R&B ROOFING & REMODELING SHOP DRAWING Louisville, KY FOR GC / ARCHITECT APPROVAL			
PROJECT TEXAS ROADHOUSE — CLARKSVILLE			
LOCATION 4615 Medical Plaza Way, Clarksville, IN 47129			
SHEET TITLE 5V ROOF VENT — FABRICATION			
GENERAL CONTRACTOR Buffalo Construction, Inc.		ARCHITECT SEE CONTRACT DOCS	
DRAWN BY J. ALLEE	CHECKED —	DATE 09/04/2026	JOB NO. 26-TR-009
SCALE AS NOTED	SUBMITTAL #2.05 R0 (07 72 00)		SHEET SM-2 OF 2

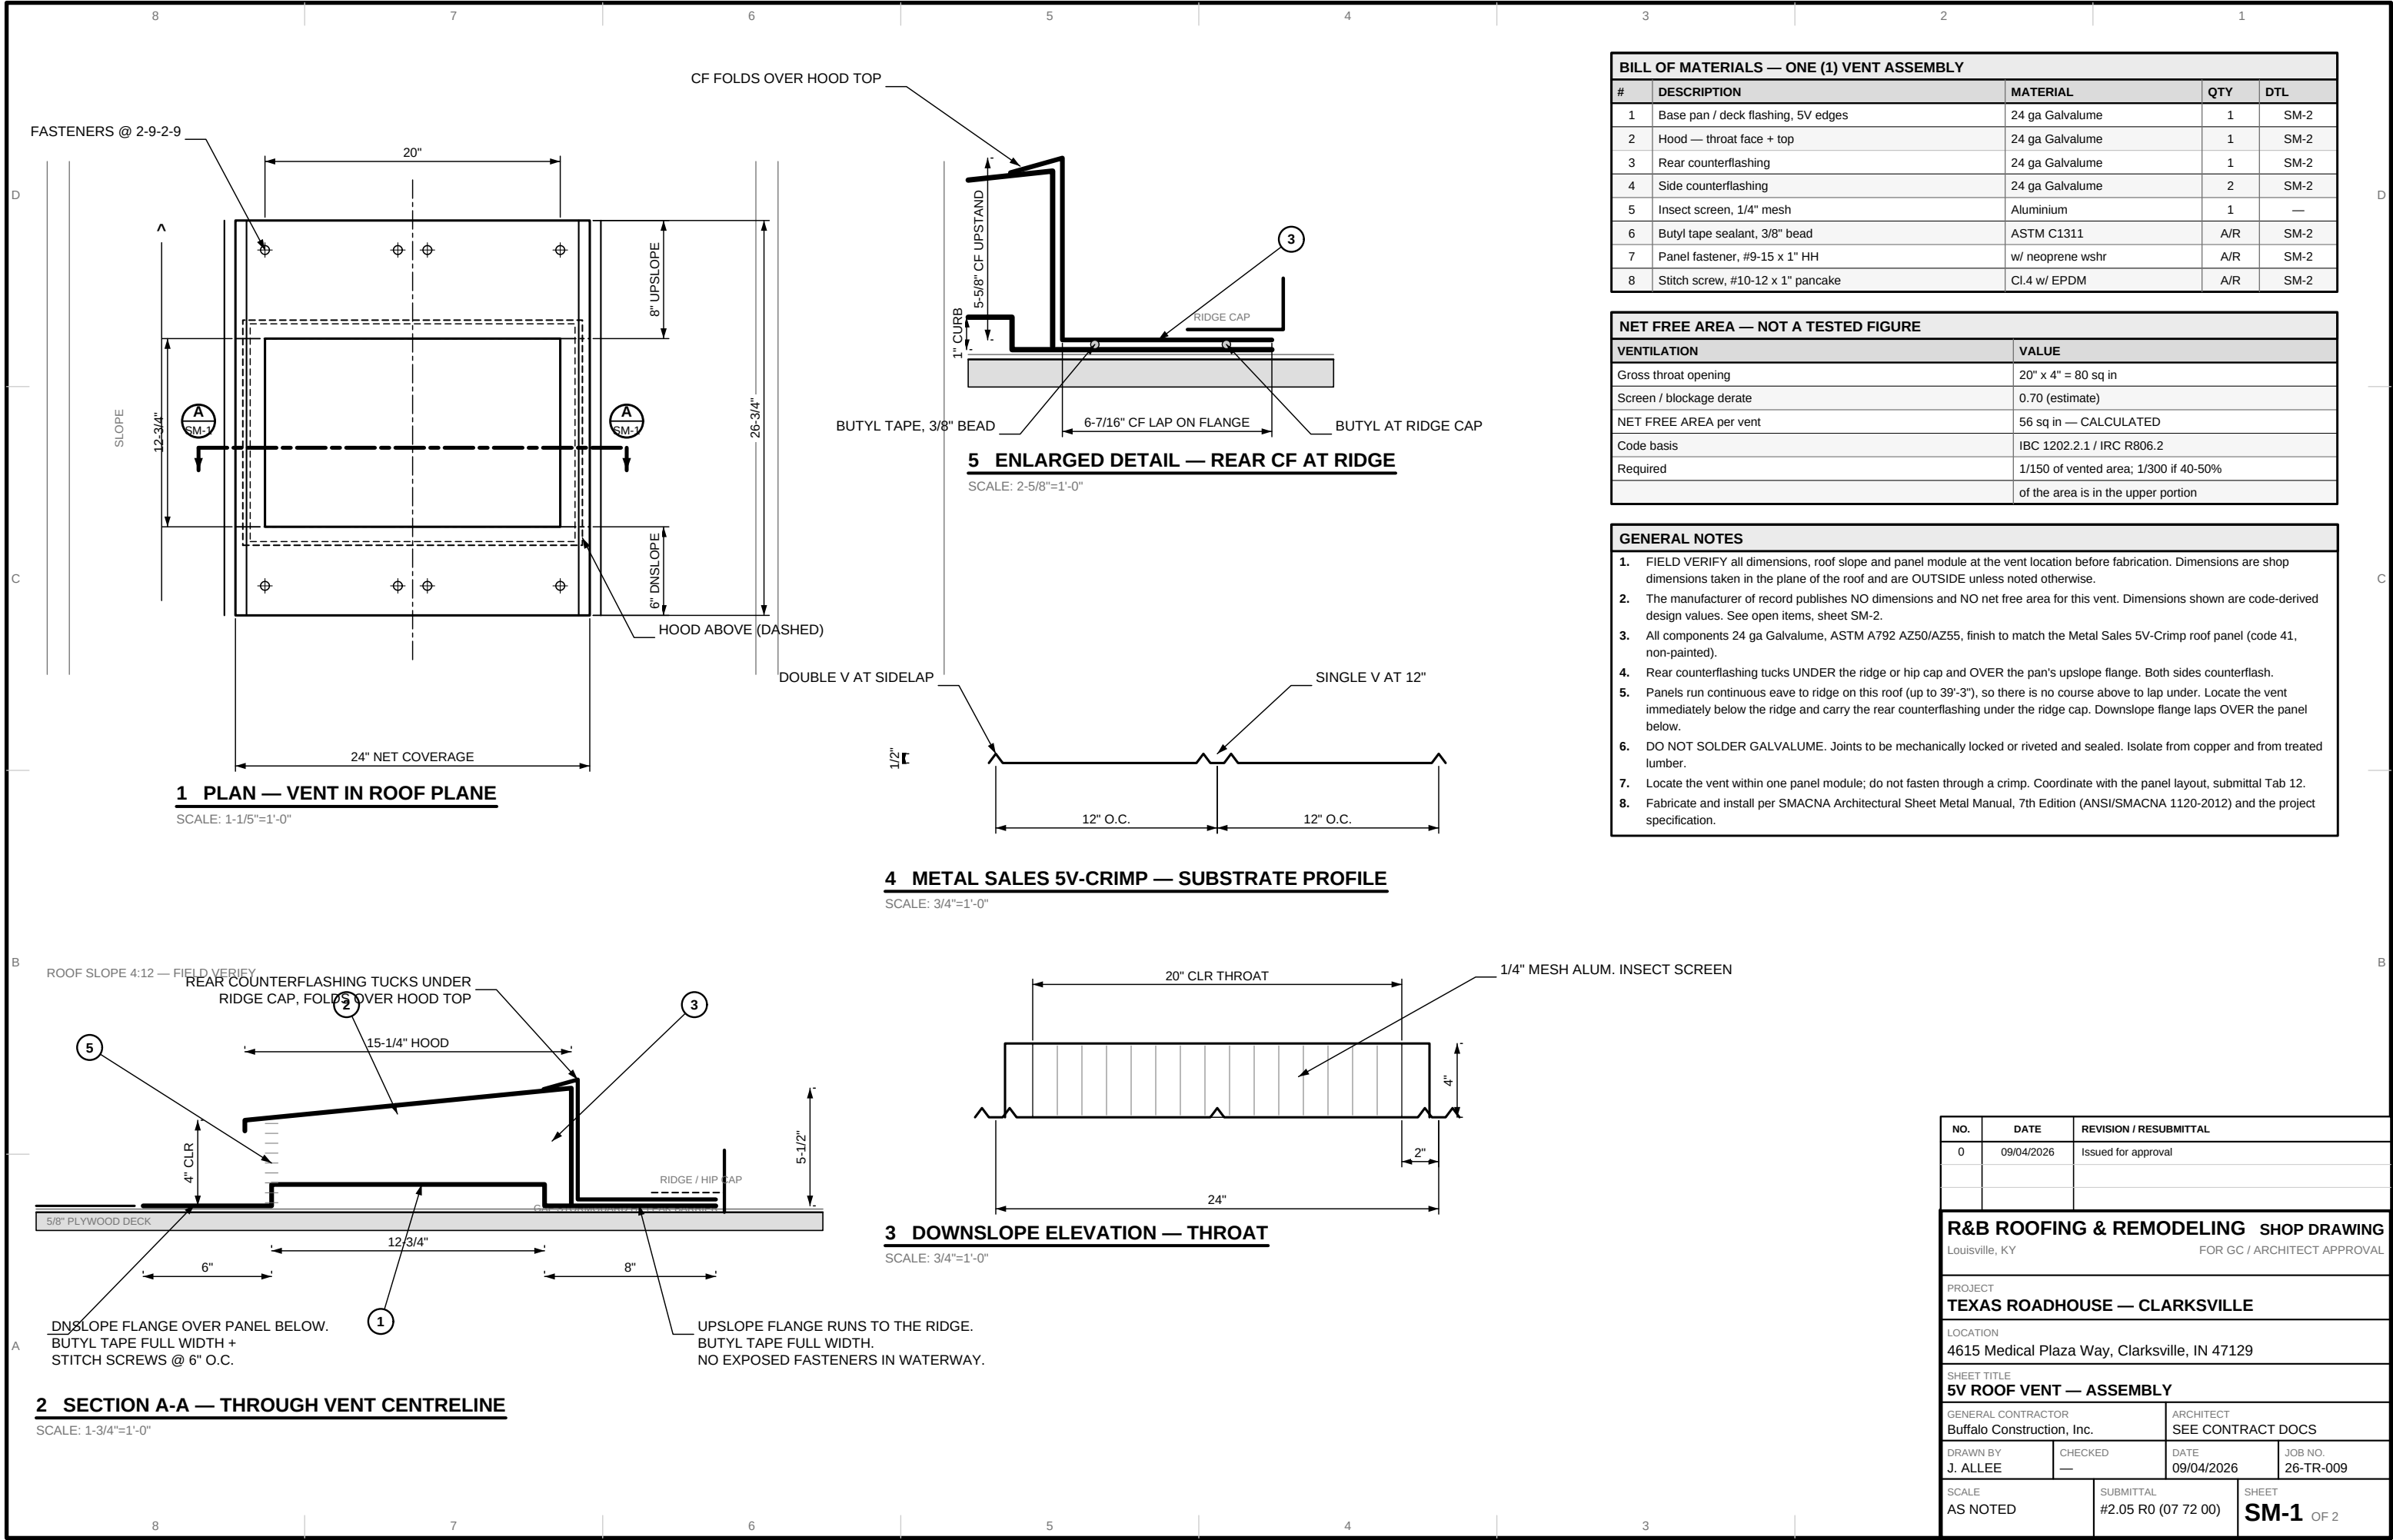
OPEN ITEMS — RESOLVE BEFORE FABRICATION	
1.	SUBMITTAL DEFECT: the Tab 9 cut sheet is titled "Proper Installation of a Vent on a STANDING SEAM Metal Roof System" and states the vent "sits on TOP of the standing seam rather than on the flat section of the panel." The TOC and tab divider call it 5V. No 5V vent literature was submitted and nothing describes how it laps into a 5V panel.

2.	Tab 9 carries NO dimensions, NO model number, NO gauge and NO net free area — it is a one-page sales flyer. Every dimension on this drawing is therefore new information not covered by the approved submittal.

3.	No metal-roof penetration detail was submitted. Metal Sales manual p.17 cross-references "ROOF PENETRATION (SEE PAGE 25)" but only manual pages 17-19 are in the binder.

4.	Net free area — not published by DCSM for any size. Ventilation compliance under IBC 1202.2.1 / IRC R806.2 cannot be demonstrated until a tested figure is obtained.

5.	No project roof slope appears anywhere in the 65-page binder; only Metal Sales' generic 3:12 minimum. Confirm the actual pitch at the vent.
6.	DCSM's own 5V spec sheet states 23-1/2" coverage while their Miami-Dade NOA 19-0109.04 drawing shows 24". The specified Metal Sales panel is 24". Confirm the vent is built to the 24" module.

7.	Sidelap double-V spread, V rib base width and V included angle are not published by Metal Sales, DCSM or the NOA. Measure from an actual panel.
8.	Fastener conflict within the binder: p.35 lists #10-14 x 1" ABMP XL, UL 580 Const. #435; p.58 cites Const. #579 & #453, which specify #9-15 x 1" Type A. Confirm which governs.

9.	Vent gauge: 26 ga to match the roof panel per DCSM's "same gauge as your main roof" rule, or 24 ga per UFGS Table I for base flashing. This drawing shows 24 ga.

10.	Quantity of vents is not stated in the submittal and no vent line item appears on the QXO cut list. Confirm count and locations.
